MFL - Metal Flashing

WEBSTER UNIVERSITY ISB
PROJECT NAME

RE: Clay Face Brick Product Data

SUBJECT: Submittal 945-02, Rev #0 Masonry materials

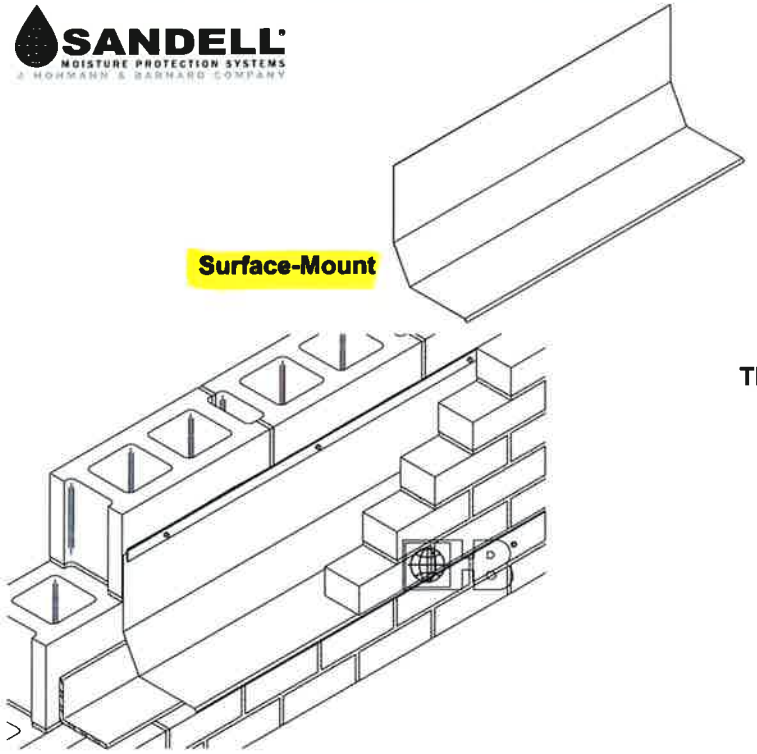
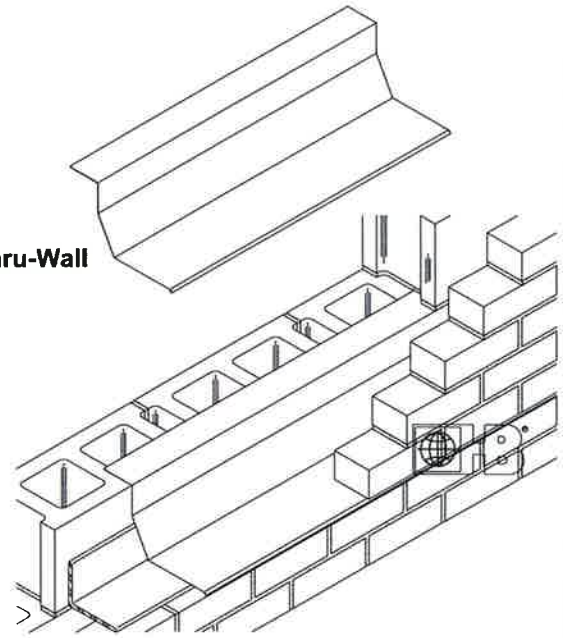
provide 1/4" drip edge per drawings.
Overlap at expansion locations 6" min. with sealant. solder at all other locations. Provide information on sealant manufacture and location of expansion joints. Provide layout of all locations of thru-wall flashings. Provide end dam detail and locations.
At lipped brick - a different drip edge profile is required
